SPARTON TECHNOLOGY

This letter is written to inform you that Sparton Technology's Inc. Pond Closure Cap has two cracks in the wear surface. We propose to repair these cracks and seek your comments on this procedure.

| <p>Harding Lawson Associates Engineers, Geologists & Geophysicists</p> | <p>POND AND SUMP AREA EXISTING FACILITIES BASE MAP</p> | | <p>A-1</p> |

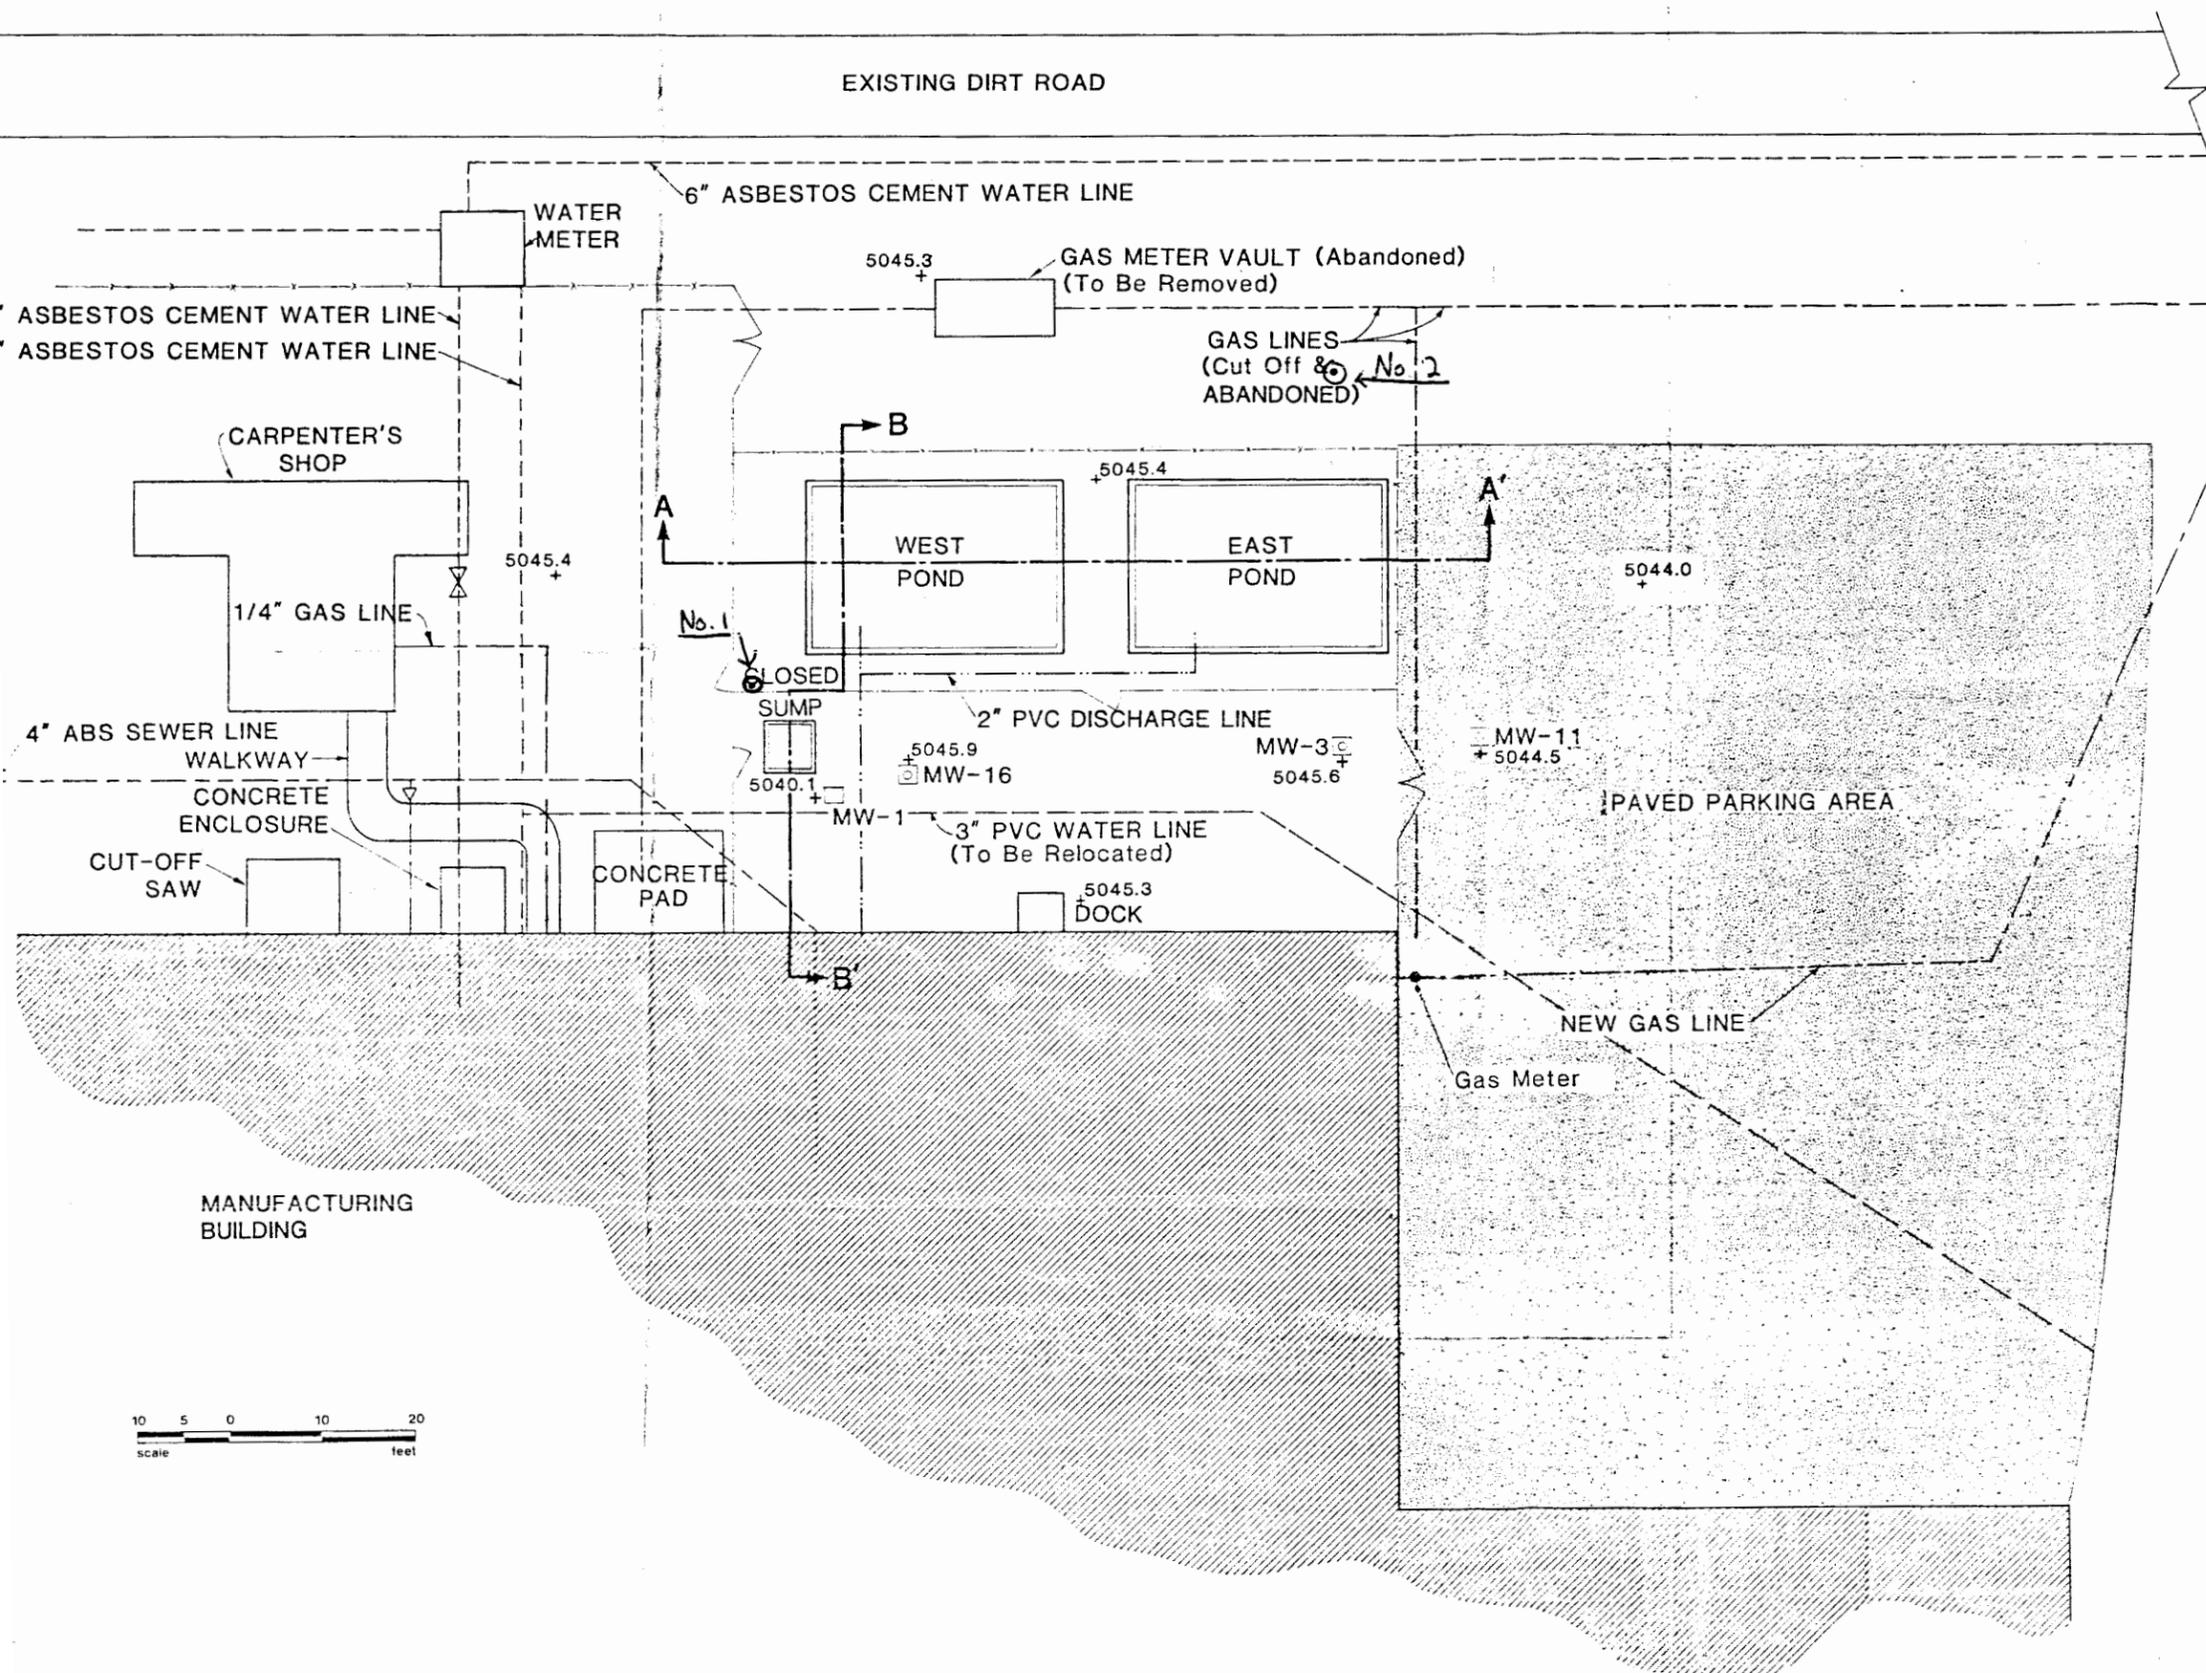
The Pond Cap is composed of 2 layers of asphaltic concrete. The base course is 6 in. thick with a tack coat on the surface. The wear coat or surface course is 3 in. thick. The dimensions of the Pond Cap are approximately 65 ft. by 75 ft.. The larger crack is located on the west side of the cap from the edge and 27 ft. to the north of the facility. The crack radiates from a 1" elevated dome and is 12 inches in it's longest dimension. The second crack is located on the northeast corner approximately 7 ft. from the east boundary and 3 ft. from the north boundary. The longest dimension is 7 in. and the surface is domed $\frac{1}{2}$ inch. We do not believe these cracks penetrate the base course but represent a delamination of the surface course. Enclosed is a copy of the Pond Cap site plan with the location of the cracks sketched in.

Sparton proposes to contract with Rodgers Water Well Co. to repair these 2 cracks. A 14 inch hole saw will cut out the 3 inch surface coat at which point the integrity of the base coat will be determined. If the base course is intact Rodgers will apply a new tack coat and asphalt layer then tamp it level with the surrounding surface. If the base coat is cracked Rodgers will cut it out. The hole will be rebuilt with 3 successive 3 inch layers of tamped asphalt with intervening tack coats.
